Access Compliance Report

Public Rights-of-Way

(Pedestrian Signals)

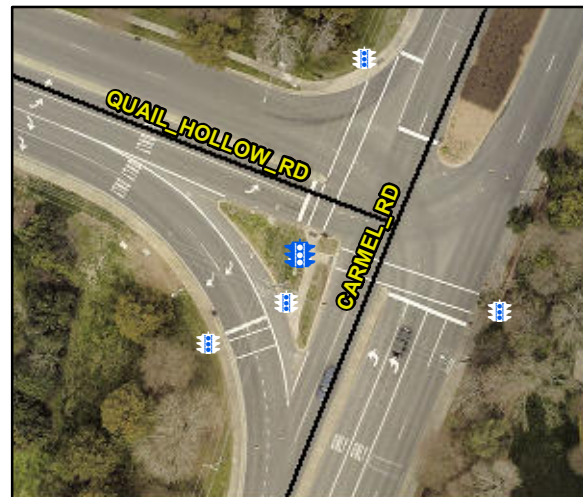
Intersection ID: N/A	Main Street:	Cross Street: N/A	Location: N/A
ADA ID: 0240B28C2D17	Signal Type: Two Push Buttons-APS	Overall Compliance: No	Severity Score: BTN 1:N/A BTN 2: N/A No BTN: N/A
Codes/Mitigation Info/Possible Solution		Field Measurements/Component Compliance

PROW/ADA: TMUTCD 4e.08, R404.1, R404.7.3, , R406.2

Yes B 1 Clear Xing Direction?	ClearlyMarked	Yes B 2 Clear Xing Direction?	ClearlyMarked
B 1 Crossing Direction	To E	B 2 Crossing Direction	To N
Yes B 1 DistanceTo XWalk (in)	0.0	Yes B 2 DistanceTo XWalk (in)	0.0
No B 1 DistanceTo Curb (in)	200.0	No B 2 DistanceTo Curb (in)	168.0
Yes B 1 Diameter (in)	2.0	Yes B 2 Diameter (in)	2.0

Possible Solutions: Replace Signal Push Button With APS Button on New Post. Remove & Relocate Sign.
